Meeting of the Village of Buffalo Grove Planning and Zoning Commission

Regular Meeting
July 20, 2022 at 7:30 PM

1. Consideration of a Preliminary Plan, Zoning Variations and a Sign Variation to Allow the Construction of a New Carwash Facility, to be Called Spotless Auto Spa at 301 N. Milwaukee Avenue (Trustee Ottenheimer) (Staff Contact: Kelly Purvis)

**VILLAGE OF BUFFALO GROVE
PLANNING & ZONING COMMISSION
STAFF REPORT**

**CAR
TURNING
EXHIBIT**

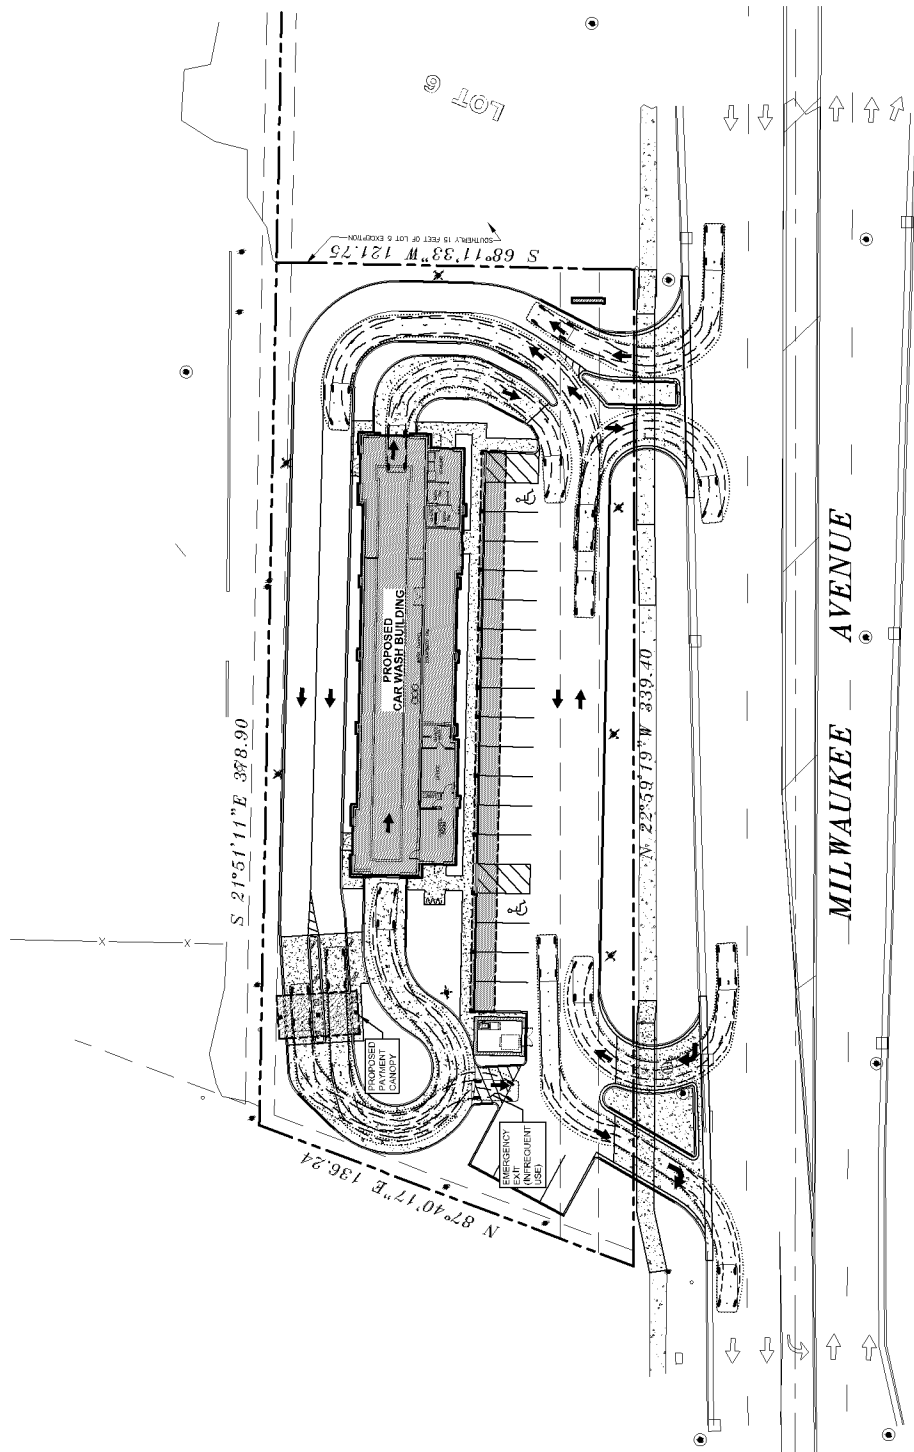
Village Department	Comments
Engineering	The Village Engineer has reviewed the preliminary engineering plans and does not have any concerns.
Forestry	The Village Forester has reviewed the landscape plan and does not have any concerns.
Police	Police has reviewed the traffic study and proposed access to the site and are supportive of the installation of a dedicated left turn lane on Milwaukee Avenue. Police did not have any other concerns about the plans for the site.
Fire	The Fire Department has reviewed the truck turn exhibit and has some concerns about a ladder truck being able to access the site.

3. *Any directional or incidental signage added to the sign package shall be reviewed administratively by staff.*
4. *The fire truck turn exhibit shall be revised to the satisfaction of the Fire Chief prior to issuance of any building permits.*
